IHB File No. S3/8151/IEC

CIRCULAR LETTER 55/2012
23 May 2012

ADOPTION OF EDITION 2.0.0 OF IHO PUBLICATION S-64
"IHO Test Data Sets for ECDIS"

Annex A: Comments by Member States (English only)

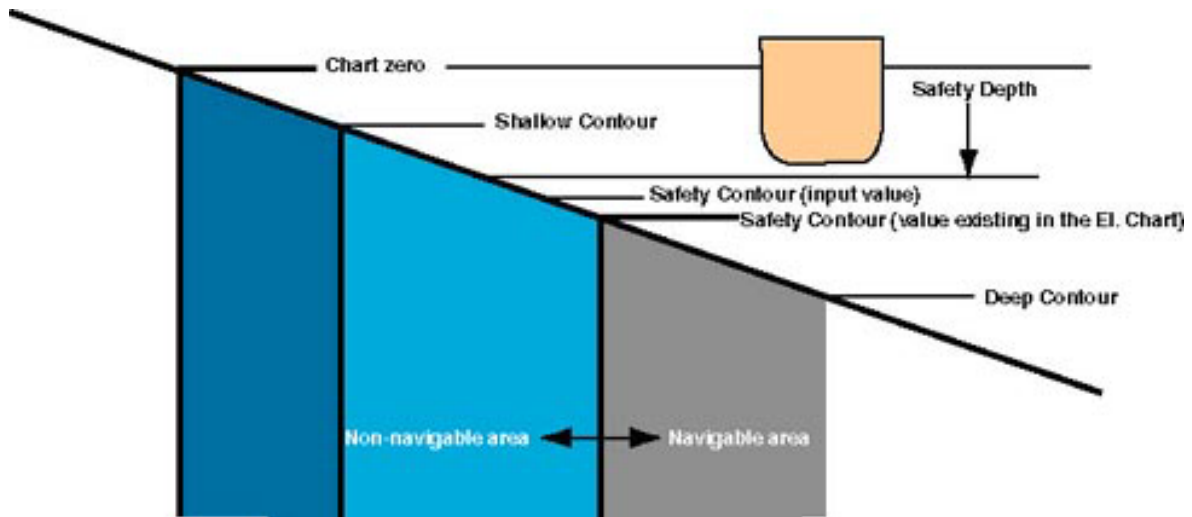
27. 6.8.15.1f: Typo update should be taken from 6.8.15.1a.
 28. 6.8.15.1h: Text of TIM and .doc file should be harmonised.
 29. 6.8.15.1i-k: IEC 61174 quotation not correct. Wording of this section should be:

- "i) if the ECDIS supports SENC delivery (accepting a SENC resulting from conversion of ENC to SENC ashore, in accordance with IHO TR A3.11, IHO Miscellaneous Publication M-3), then the manufacturer shall supply a SENC version of the IHO ENC test data subset A and subset B for each SENC format for which SENC delivery is to be approved;*

- j) for each SENC test data set supplied, verify compliance with 6.8.15.1 a) through (g) noting that the outcome of each resultant update stage should be identical to that which results from application of the updates supplied in the IHO ENC test data (subset B). Confirm by inspection of submitted documentation which Hydrographic Offices or RENCs have documented their approval of the submitted SENC version test data subsets;*

- k) if the ECDIS supports SENC delivery, confirm by using the available updates in the ENC test data set (see Annex E) that the ECDIS provides an update mechanism for delivered SENCs that is not inferior to the update mechanism of ENCs.*
